UNITED STATES PATENT AND TRADEMARK OFFICE

APPLICATION NO.	FILING DATE	FIRST NAMED INVENTOR	ATTORNEY DOCKET NO.	CONFIRMATION NO.
10/816,252	04/02/2004	David Walter Wright	115624	8511
25944 7590 04/07/2010 OLIFF & BERRIDGE, PLC P.O. BOX 320850 ALEXANDRIA, VA 22320-4850				
			EXAMINER BOWERS, NATHAN ANDREW	
			ART UNIT 1797	PAPER NUMBER
			NOTIFICATION DATE 04/07/2010	DELIVERY MODE ELECTRONIC

Office Action Summary

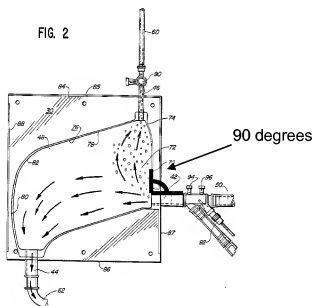
Although Figure 2 suggests that the second chamber opening is located at the top portion of the chamber, it is not entirely clear whether the second chamber opening is located in the *middle* of the top portion. From Figure 2, it appears that the second

chamber opening is located at one side of the top portion. However, it would have been obvious to ensure that the second chamber opening of Viitala is located in a middle-portion of a top portion. This would represent a mere rearrangement of parts that would not affect the functionality of the device, and instead would only represent a cosmetic design choice. Viitala does not disclose any teachings that require the second chamber opening to be positioned at one side of the top portion. Viitala only states in column 3, lines 22-25 that the sidewall (Figure 2:70) leading to the second chamber opening must be at a sharp right angle with the first chamber opening, but says nothing about the placement of the second chamber opening.

Therefore, one of ordinary skill would have found it obvious to position the second chamber opening anywhere along the top portion of the chamber. This is especially true in light of Oshiyama.

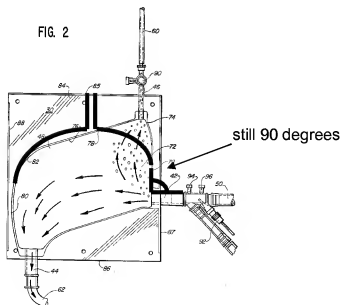
Oshiyama discloses an apparatus for separating gas from a liquid path comprising a chamber (Figure 1:12) having a top, bottom and side walls. A first opening (Figure 1:15) allows gas and liquid to enter the chamber, a second opening (Figure 1:18) is configured to allow gas to exit the chamber, and a third opening (Figure 1:17) is configured to allow liquid to exit the chamber. This is taught in column 4, line 41 to column 6, line 22. Oshiyama discloses a plurality of embodiments (see Figure 1 and 3, for example) in which the second chamber opening is positioned varying locations along the top portion.

Accordingly, one of ordinary skill would have recognized that the Viitala reference could be modified to provide a second chamber opening in a middle portion of the top portion while still maintaining the sidewall (Figure 2:70) leading to the second chamber opening at a sharp right angle with the first chamber opening.
